ADDENDUM ONE

Addendum One (AD.01) to the drawings and specifications prepared by Gibraltar Design for **Early Learning Center (ELC) and Alternative Learning Center (ALC) Additions and Renovations** for Tippecanoe School Corporation, Lafayette, Indiana.

1 A-201 ARCHITECTURAL ROOF PLAN
1/8" = 1'-0"

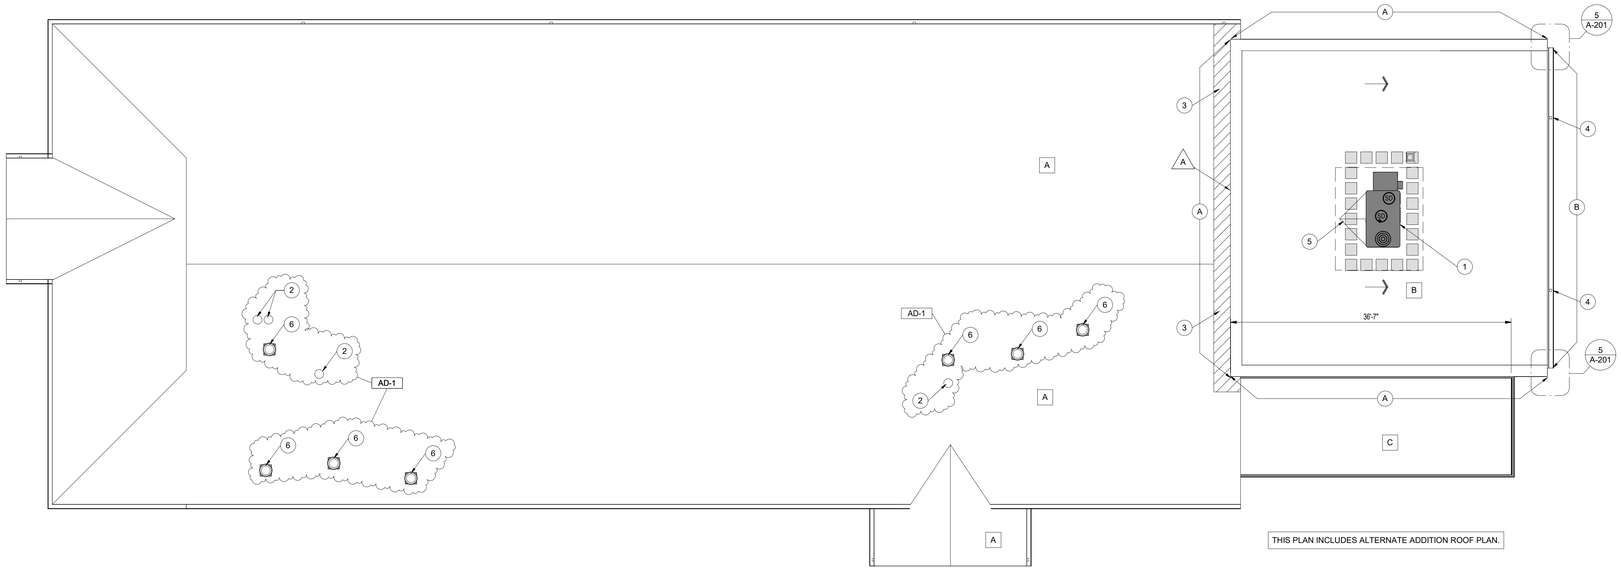
1. Architectural Roof Plan: Modify Note "2" and reference to Plumbing Vent on Roof Plan. Add Note "6" and reference to Exhaust Vent Caps on Roof Plan.
2. Roof Detail 2: Add Dimensions to Gutter.
3. Roof Detail 3: Add Plywood Note.
4. Roof Detail 4: Revise Detail.

4 A-301 **OVERALL NORTH ELEVATION**
1/8" = 1'-0"

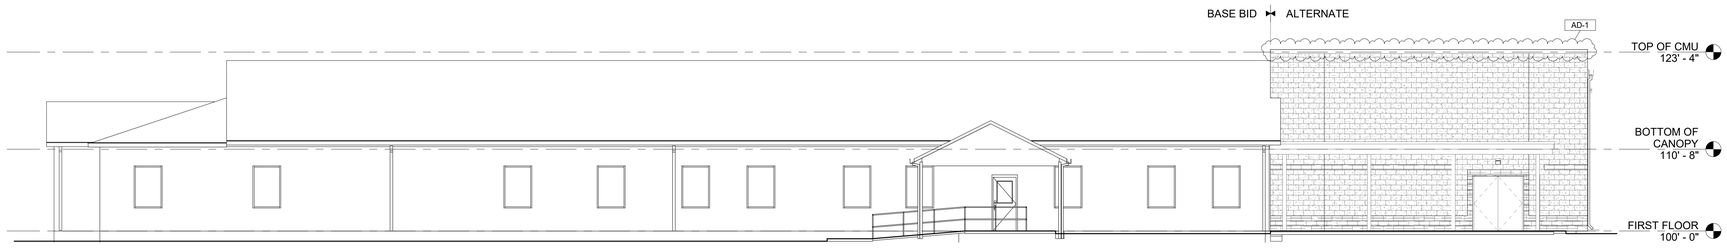
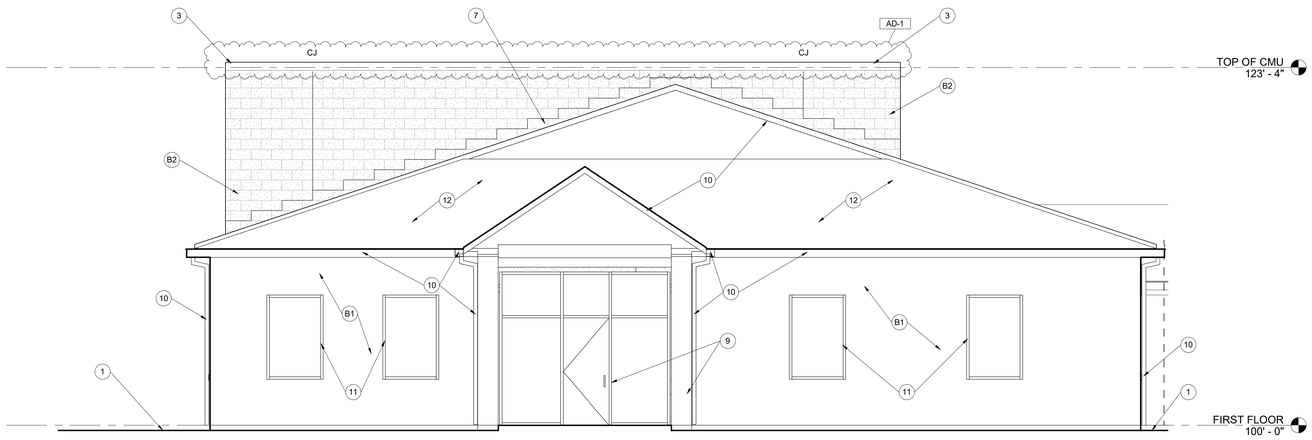
1. Overall Building Elevations: Add Parapet Coping.

9 A-501 **CERAMIC TILE BASE DETAIL**
6" = 1'-0"

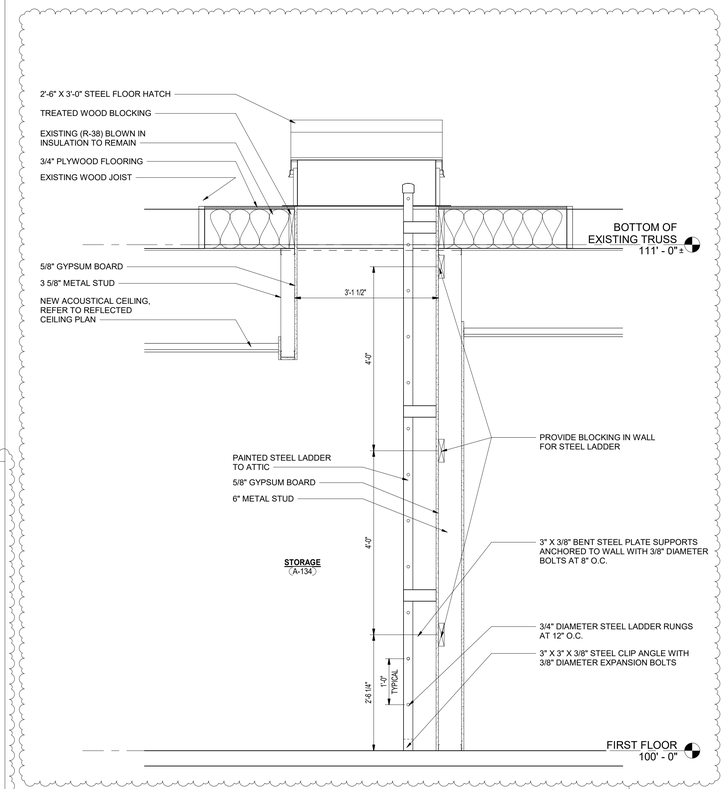
1. Revise Detail #6.
2. Add Detail #8 and #9.

1 M-101 **MECHANICAL HVAC FIRST FLOOR PLAN**
1/8" = 1'-0"

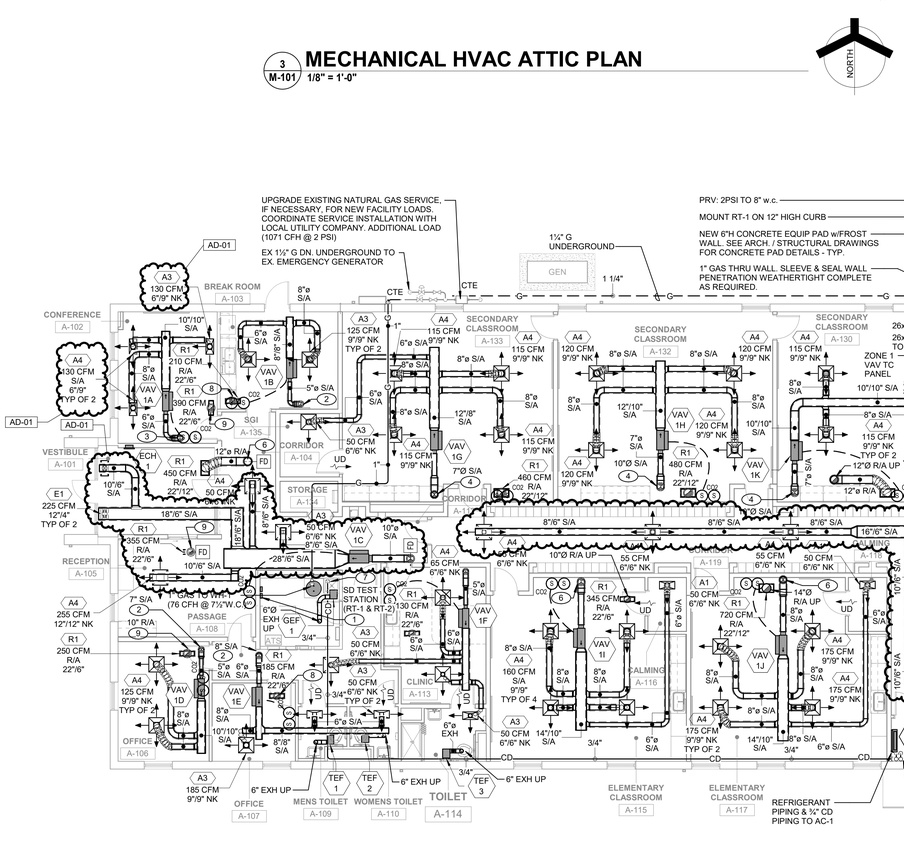
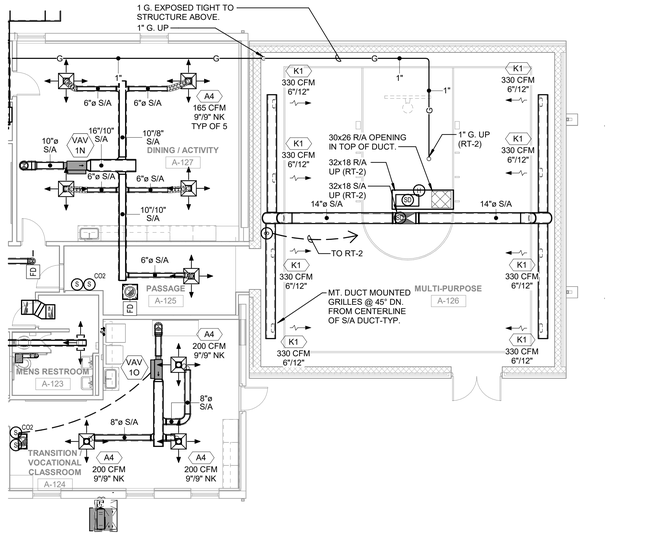
1. Revised ductwork sizes on supply air and return air ductwork to work with structure.
2. Revised ductwork sizes and layout on supply air to work with ceiling space.
3. Revised location of ECH-2.
4. Revised supply air diffuser CFM value for Conference Room A-102.
